# PREVOST

## WARRANTY BULLETIN

### WB13-32A

DATE :	JUNE 2013	SECTION :	04 - Exhaust
EXPIRATION:	JUNE 2015		
SUBJECT :	NOX SENSOR REPLACEMENT & SOFTWARE UPDATE

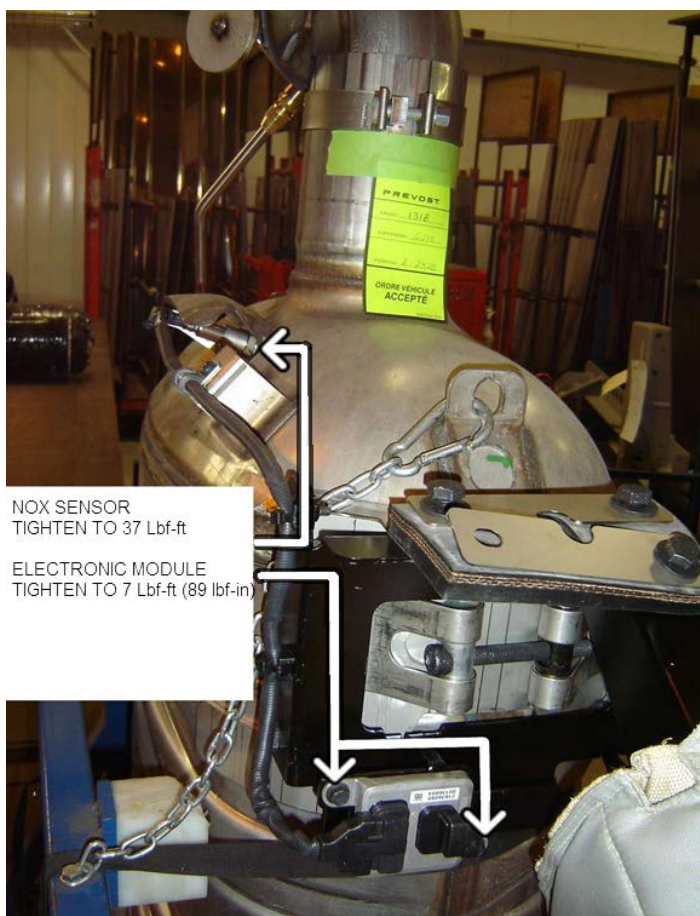
On the vehicles affected by this bulletin, the NOx sensor must be replaced and the EMS software requires an update. This must be done to allow correct emissions inspection in particular states including California.

3. Replace NOx sensor 21636088 by 22014032
4. Tighten sensor to 37 lbf-ft
5. Tighten mounting bolts to 7 lbf-ft (89 lbf-in)
6. Support with clips and cable ties
7. Update EMS software with PTT 2.0.
8. Perform MID 128 programming to update engine software and dataset at the latest revision available.
